LHC

REFERENCE
LHC-TC-EC-0015

ENGINEERING CHANGE REQUEST

Upgrade Of The Crystal Collimation Test Stand in IR7

Figure 1 — 3D view of the horizontal goniometer setup: the crystal can be inserted into the beam only when the C-shape replacement chamber is moved out (on the bottom in the figure). The 3D reference corresponding to the crystal collimator in the horizontal configuration is the ST0563346_01.

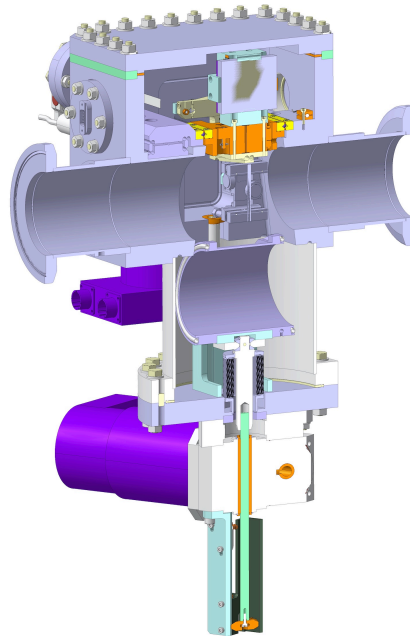
At this stage, we assume that the design of the TCPC assembly remains very similar to the presently installed hardware, see Figure 1. It relies on a movable replacement chamber that allows inserting the crystal close to the beam only in its “out” position. In standard operation for proton beams, this replacement chamber will be in its “in” position and hide the crystal from the circulating beam.

As a design requirement, possible design modifications from the present hardware must fit into the present installation slots, so that the present assemblies can be replaced with minor changes (as for example it was described in [4]). At this stage, we also assume that no additional controls cabling is required and that the present ones will be used in case new TCPCs are installed.

The detailed description of which one(s) of the 4 TCPCs shall be changed in LS2 will follow after the experiments’ results in the LHC, through an update of this document. At this stage, we assume conservatively – for resource estimates – that all the 4 TCPCs shall be replaced.
